RE: MACQUARIE PLACE MIXED USE DEVELOPMENT

VDM Consulting (Acoustics) have reviewed the current drawings for the project as follows: -

In accordance with Section F5 (Sound Transmission and Insulation) of Building Code of Australia 2009 (BCA 09) "marked up" versions of these drawings have been prepared to identify walls of differing acoustic ratings required for the project.

Marked up Floor Plans

Macquarie Place
Parramatta
Level 01
Plan

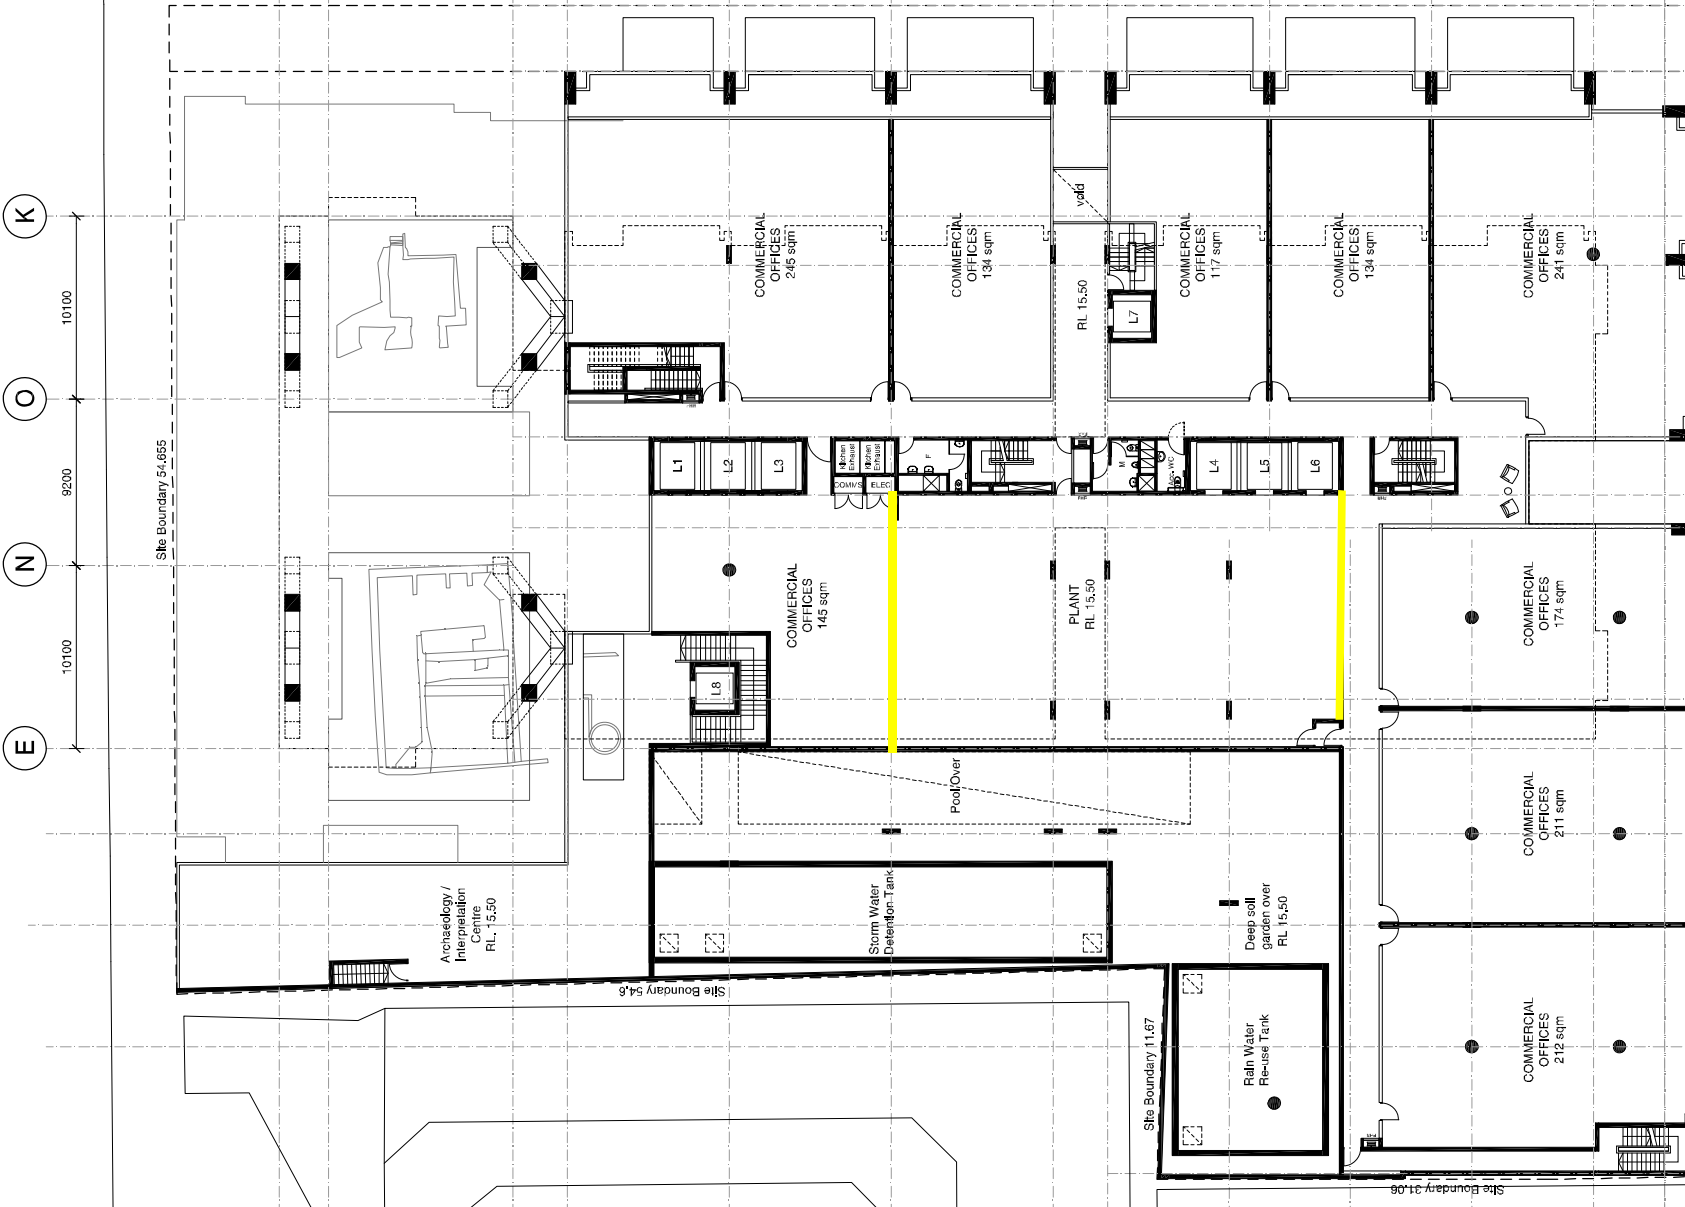
Wall Type "Yellow"

Wall type "Yellow" must have an R_{w+Ctr} (airborne) rating of not less than 50 and be of discontinuous construction. Discontinuous construction meaning that the wall provides for a minimum 20mm cavity between two separate leaves.

Wall Type "Red"

Wall type "Red" must have an $R_w + C_{tr}$ rating of not less than 50.

Wall Type "Green"

Wall type "Green" must have an R_w rating of not less than 50.
